**Re: Construction Storm Water Inspection at the Ridge at Chestnut Hill Phase 2  
Franklin County  
Permit Number 4GC03170\*AG**

This letter is written in follow-up to a construction storm water inspection conducted by Elizabeth Schaller and Vinod Tujalpuram of the Ohio EPA at The Ridge at Chestnut Hill Phase 2 in Columbus, Ohio on August 4, 2010. The purpose of the inspection was to evaluate compliance with the General Storm Water Permit Associated with Construction Activities. The following issues were noted:

Figure 1: Retrench silt fence around designated concrete washout area.

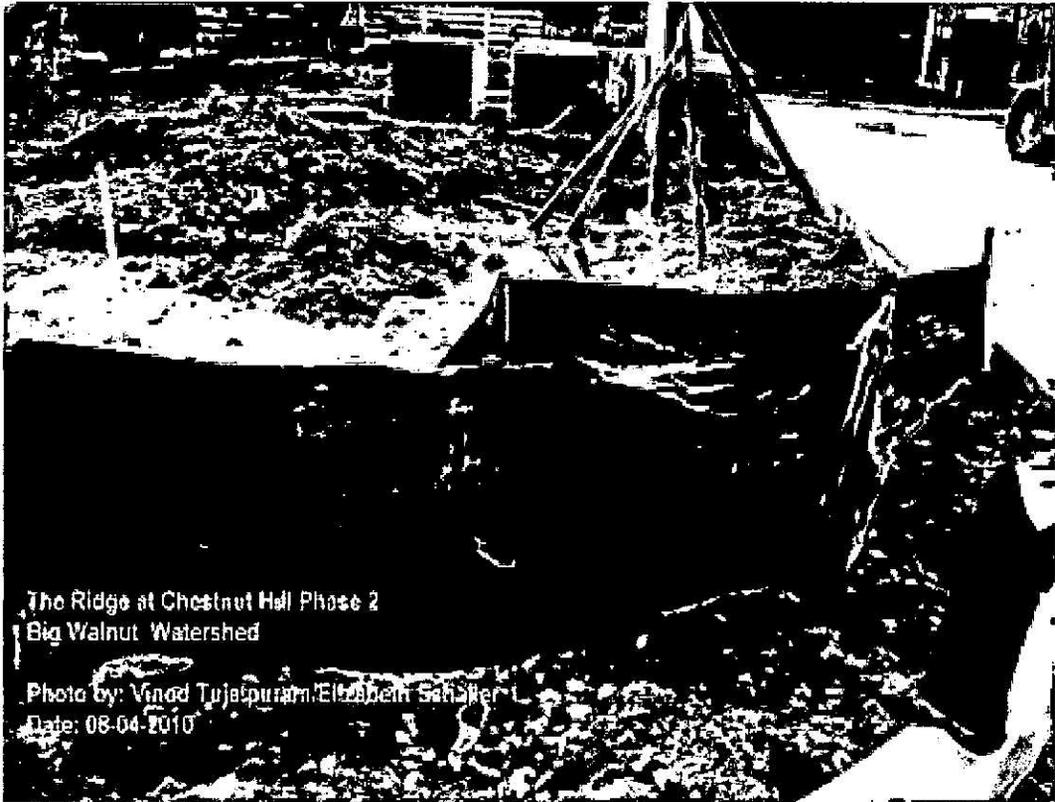
- The laterally supported inlet protection structures are not functioning as intended and require maintenance.
- The designated concrete washout is not properly contained (see Figure 1). A pit impoundment or equivalent is expected within three days from receipt of this letter.
